Miscellaneous Correspondence  
Relating Primarily to Building  
Construction Alterations & Inspections,  
1935-1937.

14. Foundation Work - PENDING Denver Mint Job

Denver, Mint Addition,  
Denver, Colo.,  
Nov. 5 th- 1935

Denver, Colo.  
Oct. 26 th. 1935

Test Hole No 3 - U.S. Mint, Denver, Colo.

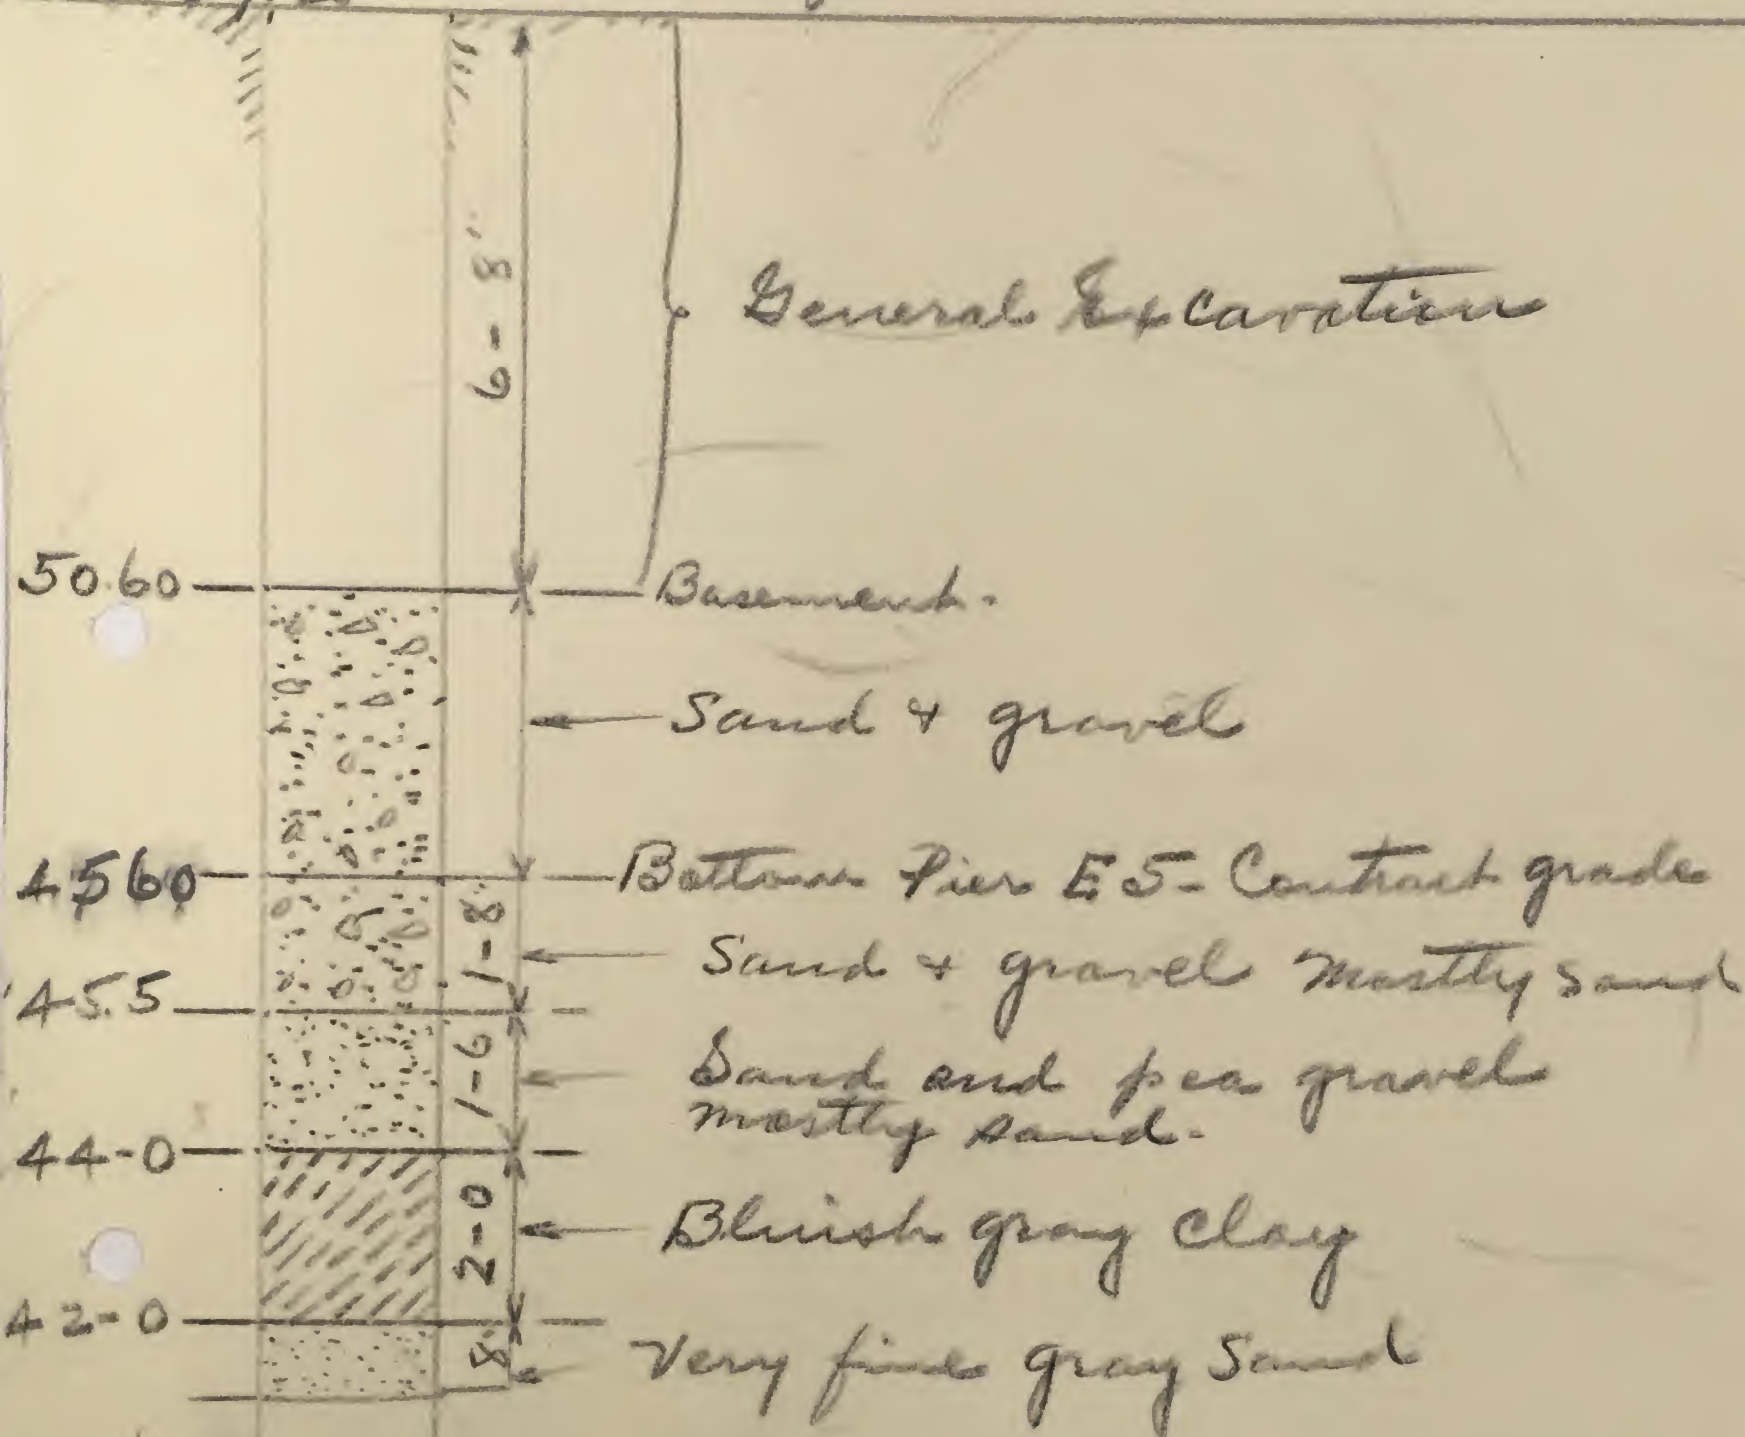
However, in the N.W. corner, under piers E-12- E-13 and under the inside row of Cols. running East along E-14 -E-5 -E19- there appears a layer of clay 2-0 to 2-3" thick that is not suitable for bearing up to 5,000 lbs. to the square foot.

Due to the designed load on the piers and the vibration that will be set up in the addition from the rolls and punching machines, I recommend that piers E-11- E-12 - E13- 14- E5 -E-19 and E-6 & E-7 be

There appears a discrepancy between the contract drawing 1-400 and the approved shop drawing for the elevation of pier E-5. The contract drawing calls for 2-0" down, while the shop drawing requires only 8" to the top of the pier. Please advise which is correct.

YOUR LETTER OF THE 26TH LAST PARAGRAPH. SUBMIT CONTRACTORS  
PROPOSAL LENGTHEN COLUMN E-5 24" MEANS SHOP SPLICED.

Denver Colorado Dist your letter twenty-sixth last paragraph submit  
contractors proposal lengthen column E five twentyfour inches means  
shop copies.

Test hole No-9- Mint Addition  
Hole located center Denver, Colo-  
pier E-4.

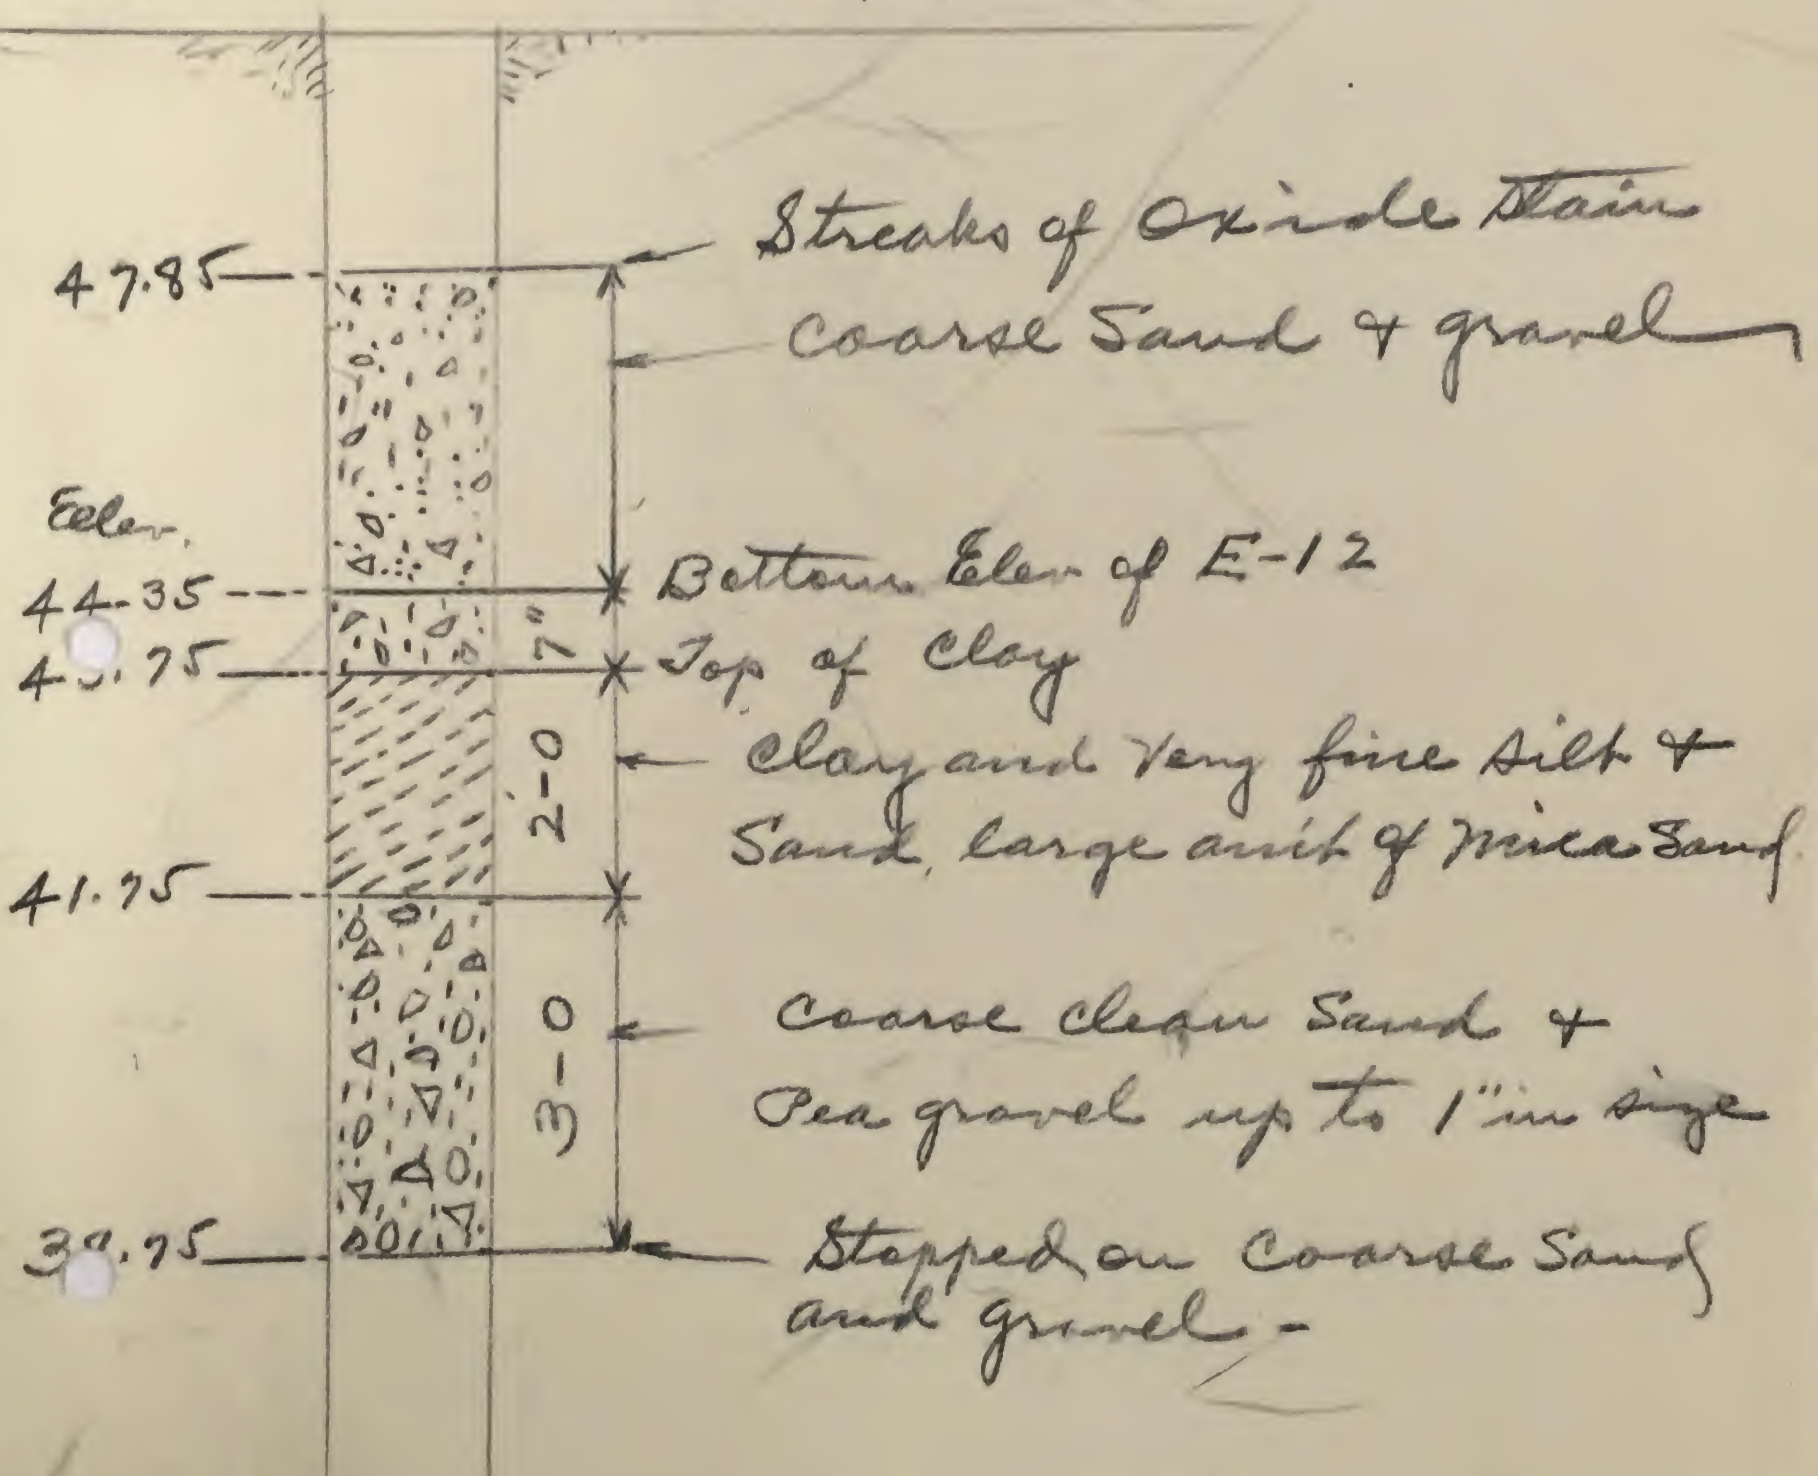
Formation about the same  
as test hole # 5 under pier  
E-3-

Lower Frostings to Elev.  
 Contrast grade - Lower -

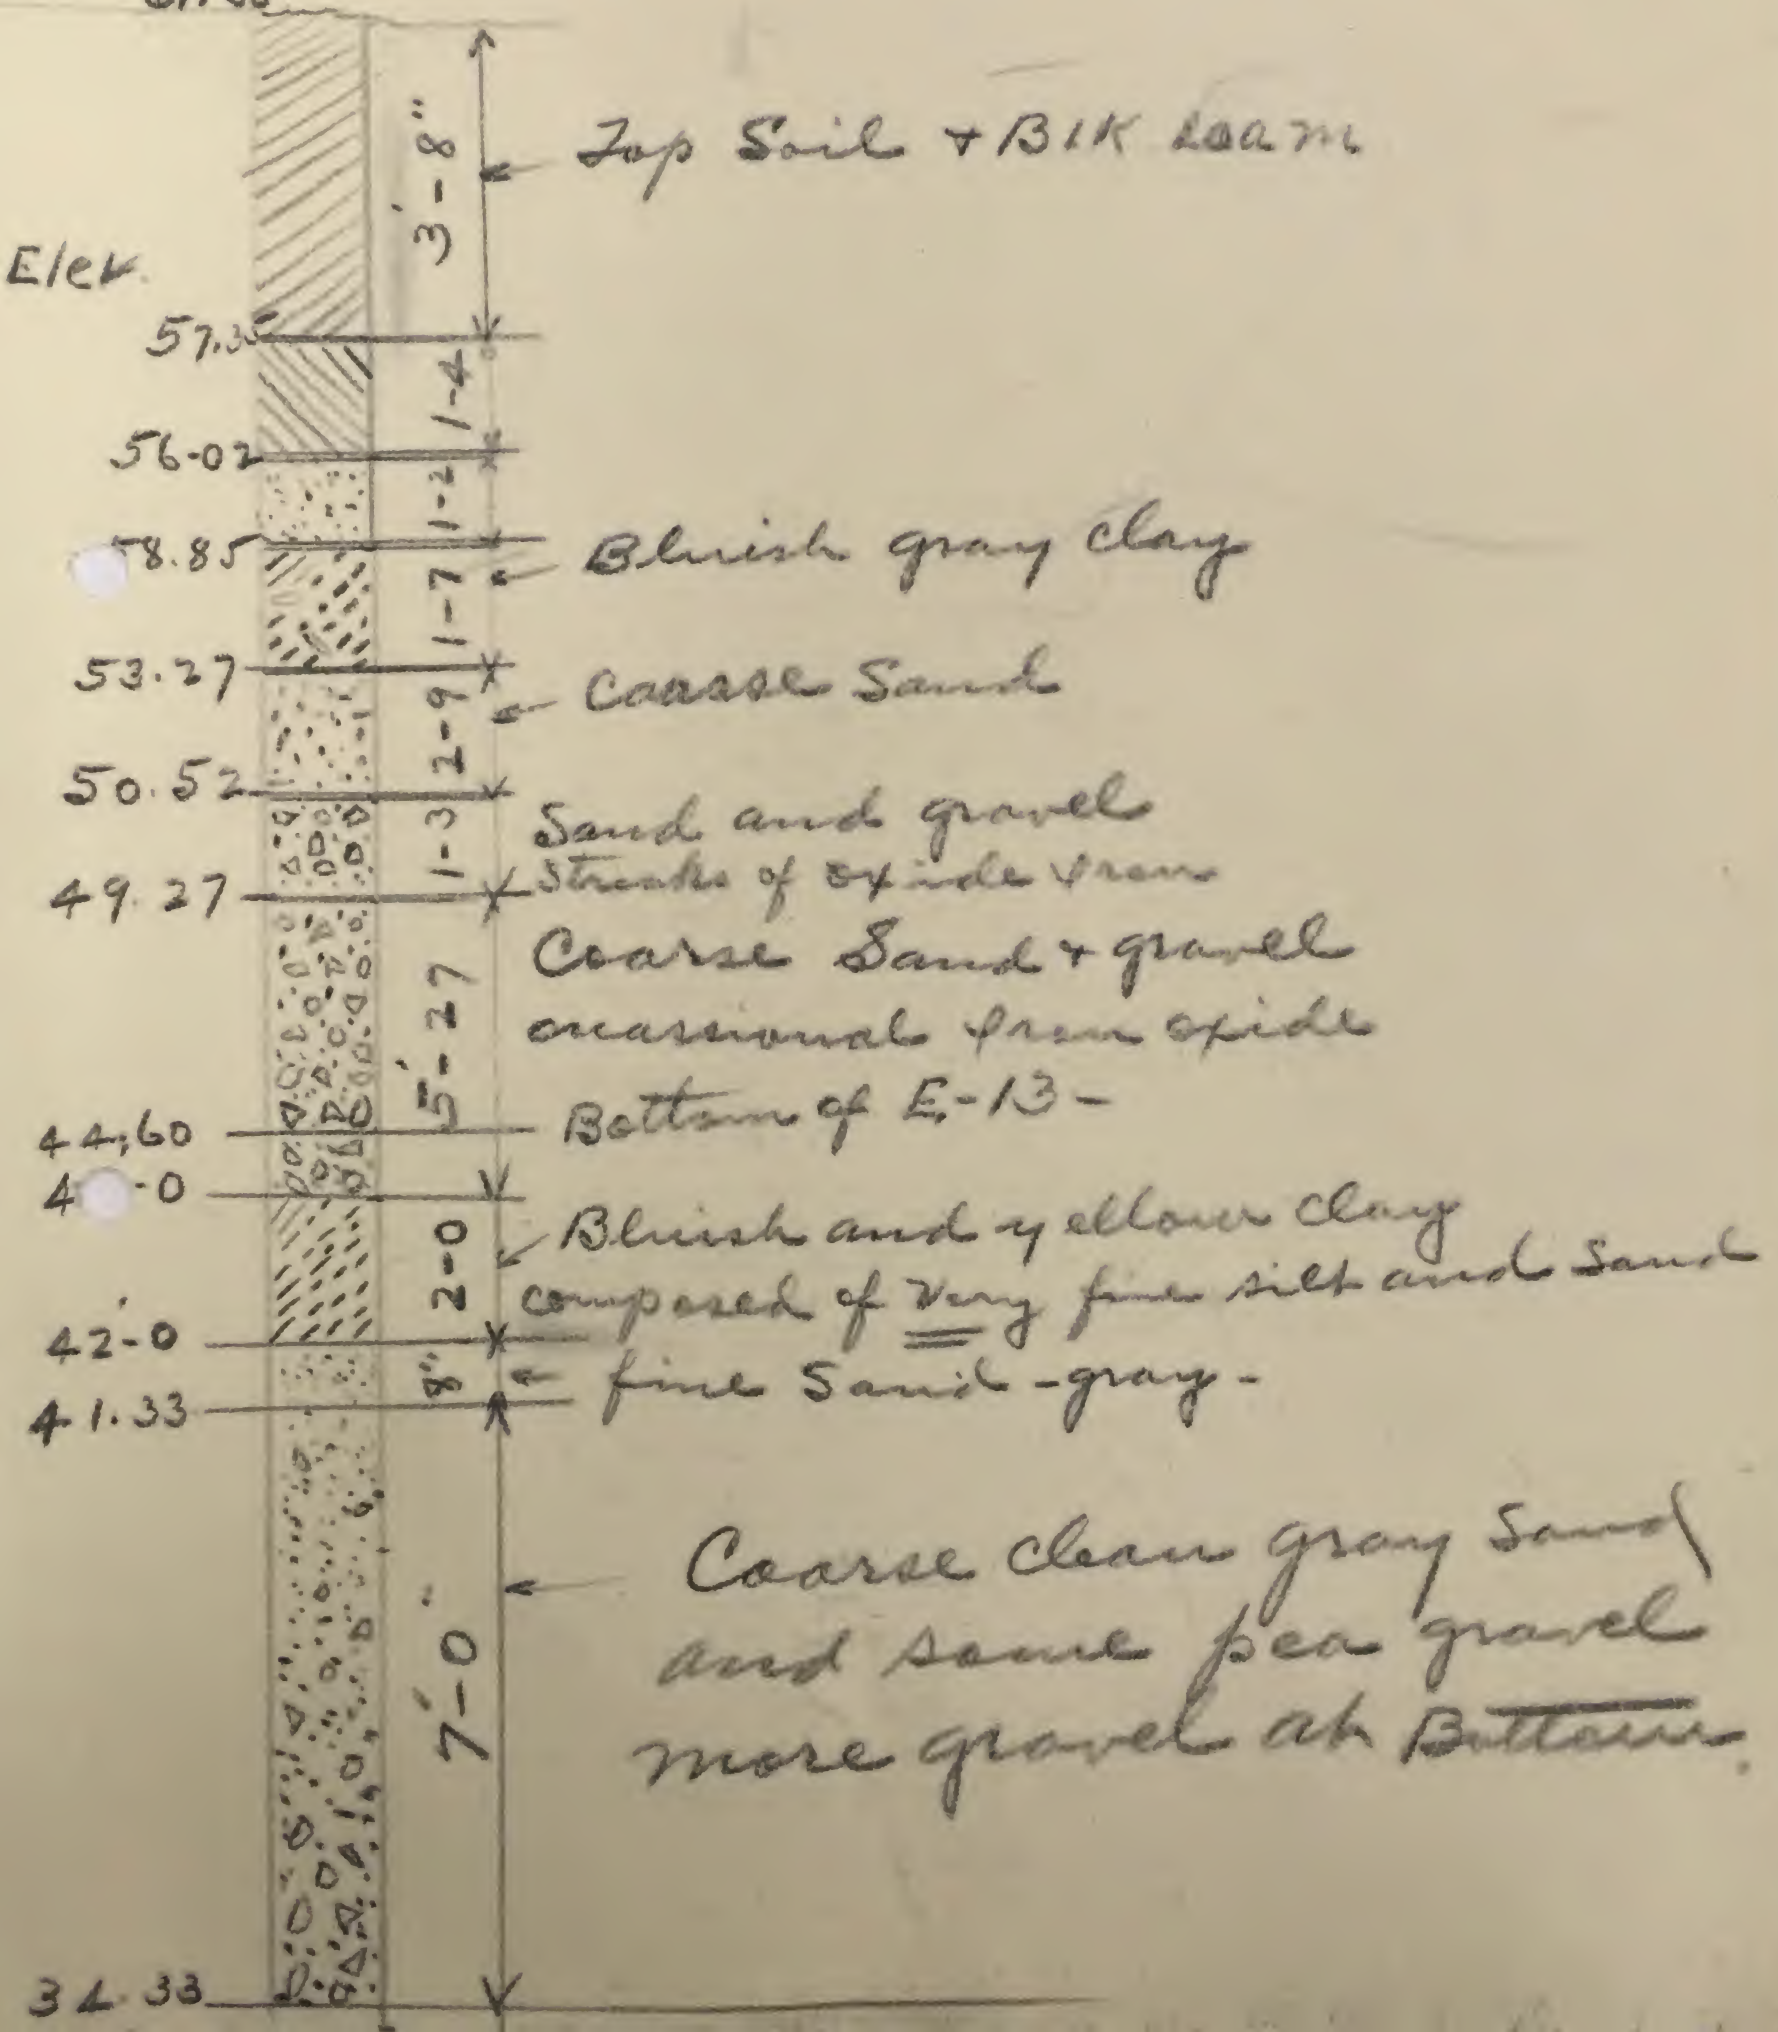
E12	(44.35) 47.02 =	3.35	41.00
13 -	44.60 - -	3.60	41.00'
14 -	46.33 - -	5.33	41.0'
5 -	45.52 - -	4.52	41.0'
19 -	48.02 - -	7.02	41.0'
6 -	47.33 - -	6.33	41.0
7 -	46.98 - -	5.98	41.0
4 -	47.27 - -	6.27	41.00

4-12 -	47.02 - -	3' - 27"	
13	44.50 - -	66" - or 8" in Clay	
14	46.33 - -	2' - 33"	
5	45.52 - -	1.52	
19 -	48.02 - H -	4 - 02	
6 -	47.33 - -	3.65	
7	46.98 - -	3.80 -	
4 -	47.27 - -	3.27	
3 -	47.02 -	Coarse Sand (H) + 43.0

YOU AUTHORIZED HAVE CONTRACTOR PROCEED LOWER FOOTINGS AS NECESSARY TO  
REACH SUITABLE MATERIAL AT COST PLUS TEN AND TEN TOTAL  
NOT TO EXCEED ESTIMATE ONE THOUSAND DOLLARS AS ADDITION HIS  
CONTRACT PERIOD FOOTINGS TO REMAIN AS DESIGNATED AND INCREASED HEIGHT  
EFFECTED BY PEDESTALS HAVING DIMENSIONS ONE FOOT GREATER EACH WAY  
THAN STEEL FILLET SUPPORT
